Crystal River Nuclear Plant
Docket No. 50-302
Operating License No. DPR-72

January 31, 2012
3F0112-11

Subject: Crystal River Unit 3 – Corrections to the Extended Power Uprate LAR #309
Vendor Affidavit and Technical Report (TAC No. ME6527)

REVISED PAGES OF THE CR-3 EPU TECHNICAL REPORTS

The sequence of events for the turbine trip accident is listed in Table 2.8.5.2.1-1 and the calculated results are tabulated in Table 2.8.5.2.1-2. Figures 2.8.5.2.1-1 through 2.8.5.2.1-5 show transient plots of the significant plant parameters following a turbine trip accident.

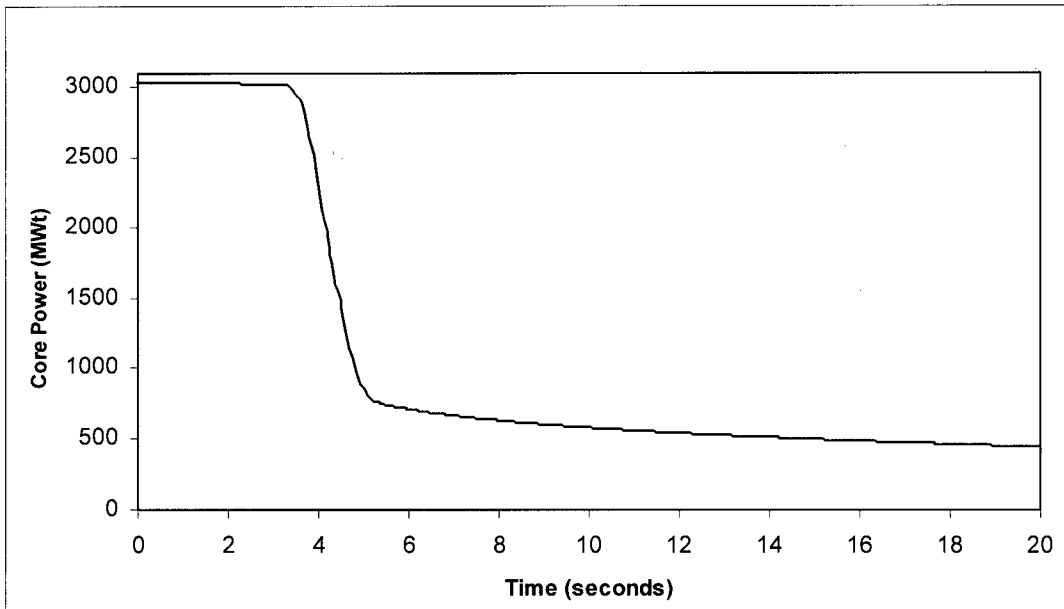
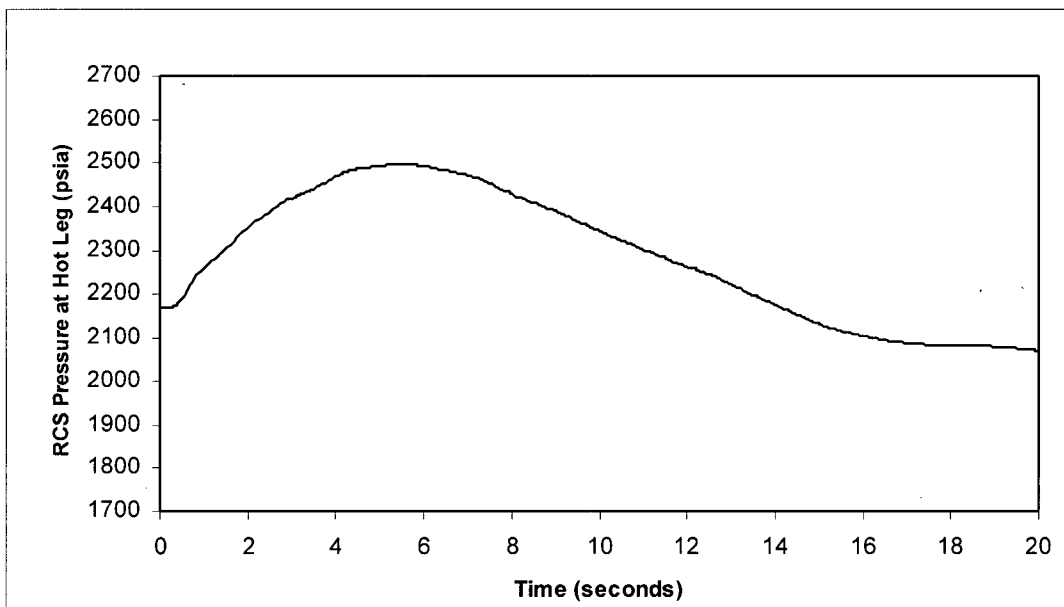
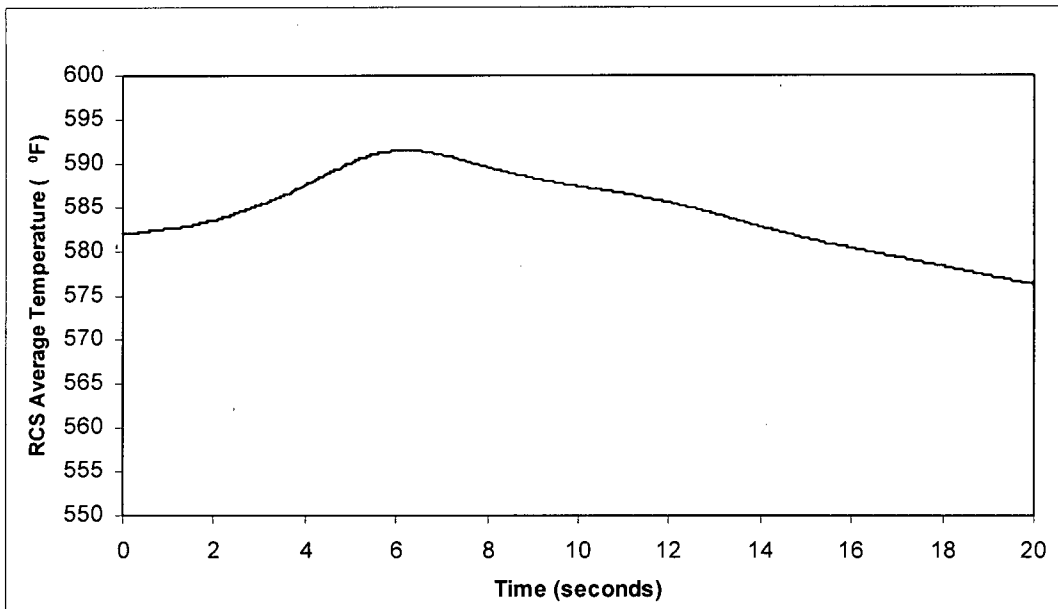
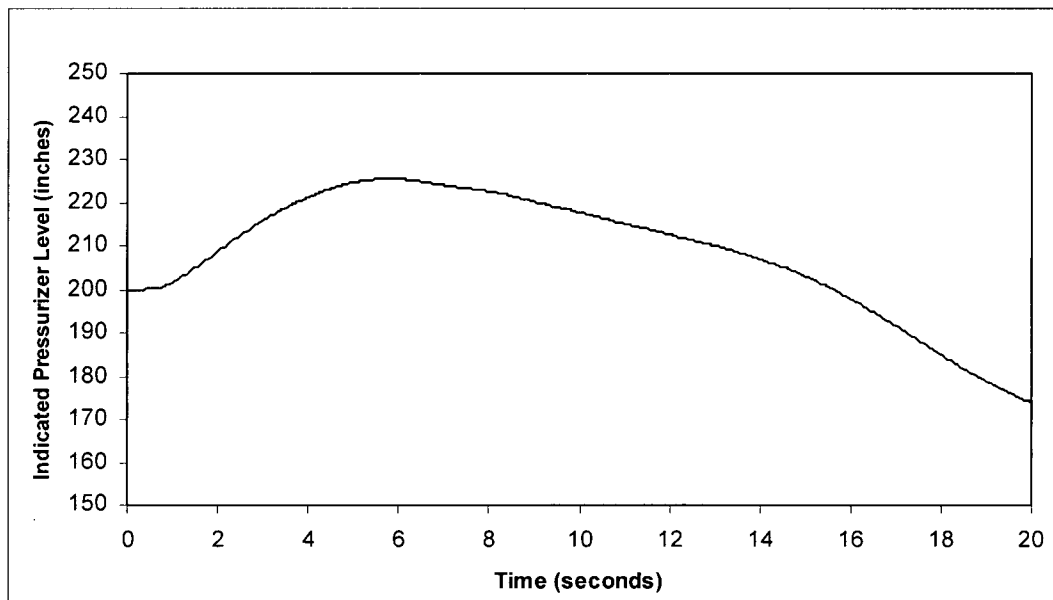
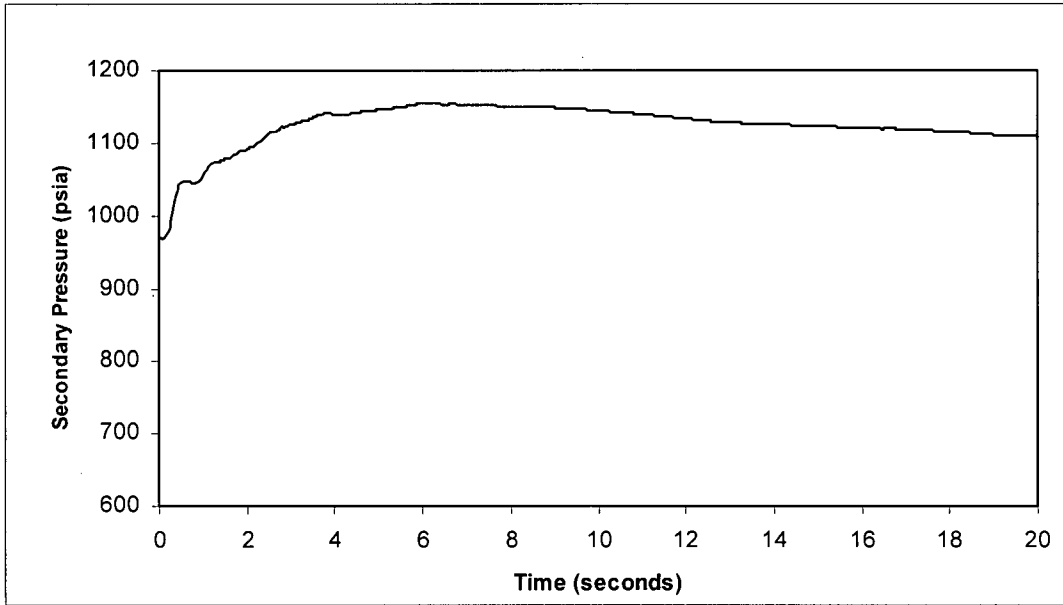
Attachment B, “Revised Pages of the CR-3 EPU Technical Report,” provides a revision to the CR-3 EPU Technical Report (TR) to correct initial conditions and results of Section 2.8.5.2.1, “Loss of External Load, Turbine Trip, Loss of Condenser Vacuum, and Steam Pressure Regulatory Failure,” and ancillary corrections to Table 2.8.5.0-7, “Non-LOCA EPU Analysis Limits and Analysis Results.” During a vendor review of the documents supporting the CR-3 EPU TR, it was determined that the main feedwater (MFW) isolation was modeled coincident with a reactor trip. This is inconsistent with the analysis input summary document, which states that MFW isolates coincident with a turbine trip. To determine the impact of this inaccuracy, sensitivity cases have been run for the turbine trip event, assuming the MFW trip isolates coincident with a turbine trip. This does not affect the conclusion that the proposed EPU is acceptable with respect to the turbine trip event. Table 2.8.5.0-7 also includes a clarification for Note 9 to provide more specific detail regarding the acceptability of the results associated with the Locked Rotor Accident. In addition, Figures 4 through 7 of Enclosure 2, “ADV/Fast Cooldown System Modification,” to Appendix E of the CR-3 EPU TR have been revised to

The RCS pressure peak was reached at 5.5 seconds and remained below the limit of 2764.7 psia. The peak steam line pressure and the peak OTSG pressure were reached at 6.0 seconds. The steam line maximum pressure was less than the corresponding limit of 1169.7 psia and the OTSG peak pressure was below the limit of 1279.7 psia.

FIGURE 4: OTSB 3B – ATMOSPHERIC DUMP VALVE (CURRENT)

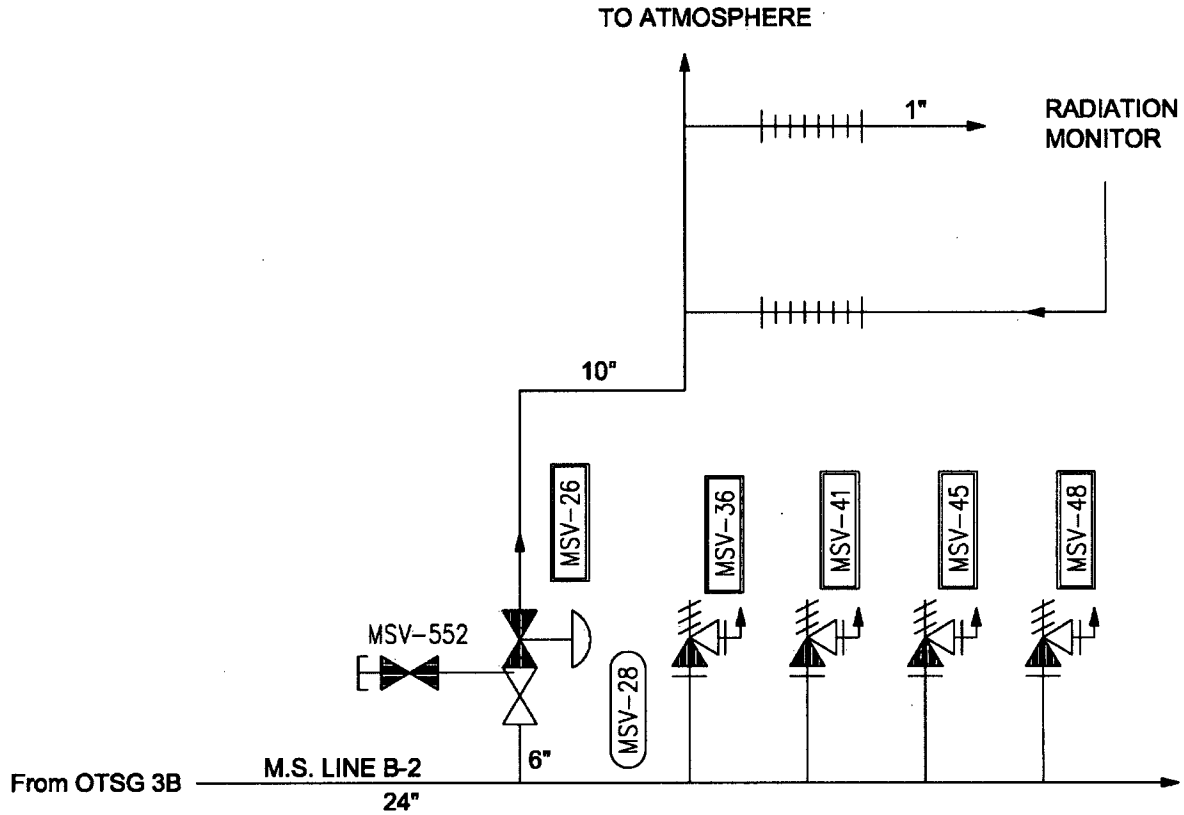
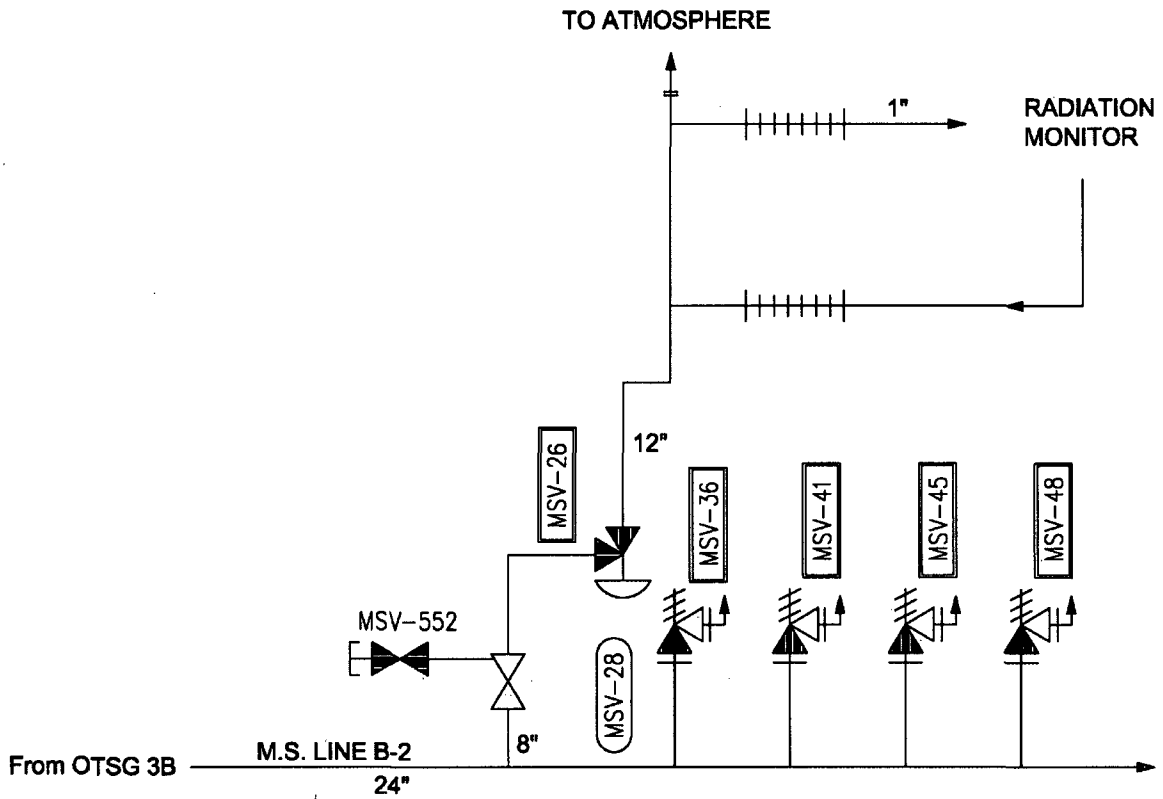
provide the correct valve numbers and lines sizes to be consistent with the related text in the enclosure and the current atmospheric dump valve (ADV) design. This administrative oversight, with the inaccurate valve and line identifications, do not adversely affect the EPU safety analyses, ADV modification design, or operational aspects of the Fast Cooldown System (FCS) or ADVs. Please remove and replace the CR-3 EPU TR pages, in copies of Attachment 5 and Attachment 7 of the CR-3 LAR #309 (Reference), with the attached revised pages.
